DRAWING NO. D407-667-145	TITLE CROSSTUBE ASS'Y (407 HIGH FWD)	REV. C	DART AEROSPACE LTD ENGINEERING ORDER		D.E.O. NO. D407-667-145-C-1	SHEET NO. SHEET 1 OF 1	SCALE NTS
DRAWN <i>Q</i>	CHECKED <i>ASS</i>	MFG. APPR. <i>IB</i>	APPROVED <i>WD</i>		DE APPR. <i>##</i>		
DATE 11.07.15	DATE 11.07.22	DATE 11.07.22	DATE 11/07/22		DATE 11.07.21

REPLACE MAGNOBOND WITH PROSEAL.

DRAWING NO. D407-667-145	TITLE CROSSTUBE ASS'Y (407 HIGH FWD)	REV. C	DART AEROSPACE LTD ENGINEERING ORDER		D.E.O. NO. D407-667-145-C-2	SHEET NO. SHEET 1 OF 1	SCALE NTS
DRAWN AJS	CHECKED	MFG. APPR. <i>E</i>	APPROVED <i>140</i>	DE APPR. <i>[Signature]</i>			
DATE 12.08.02	DATE 12.08.02	DATE 12.08.02	DATE 12.08.02	DATE 12.08.02	DATE 12.08.02

ADD ELECTRICAL GROUNDING STRAP

DETAIL P
BONDING STRAP INSTALLATION 2 PL

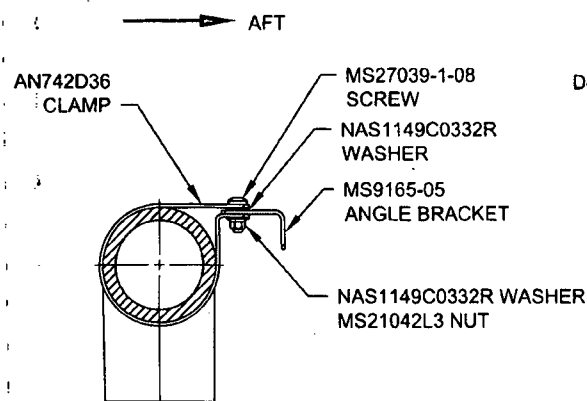
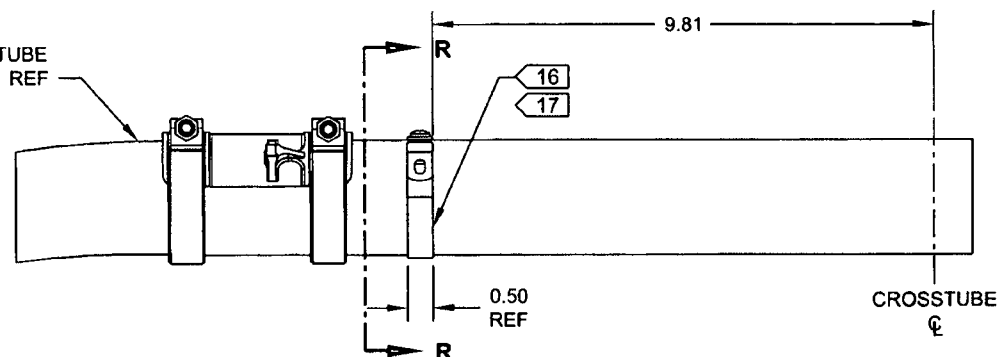
ITEM	QTY -145	PART NUMBER	DESCRIPTION
1	X	D407-667-145	CROSSTUBE ASSEMBLY (407 HIGH FWD)
<i>[Lightning Bolt Symbol]</i>			
10	2	AN742D36	CLAMP
11	2	MS9165-05	ANGLE BRACKET
12	2	MS21042L3	NUT (OR MS21042-3)
13	2	MS27039-1-08	SCREW
14	4	NAS1149C0332R	WASHER (OR AN960C10L)

- 16) MASK AREA UNDER CLAMP PRIOR TO PAINTING
- 17) SEAL EDGES WHERE AN742D36 CLAMP MEETS WITH THE CROSSTUBE USING SIKAFLEX-241/-291 OR MIL-S-8802 CLASS B2 OR PROSEAL 890 SEALANT
- 18) PERFORM RESISTANCE CHECK TO ENSURE MAX RESISTANCE IS 10 MILLIOHMS
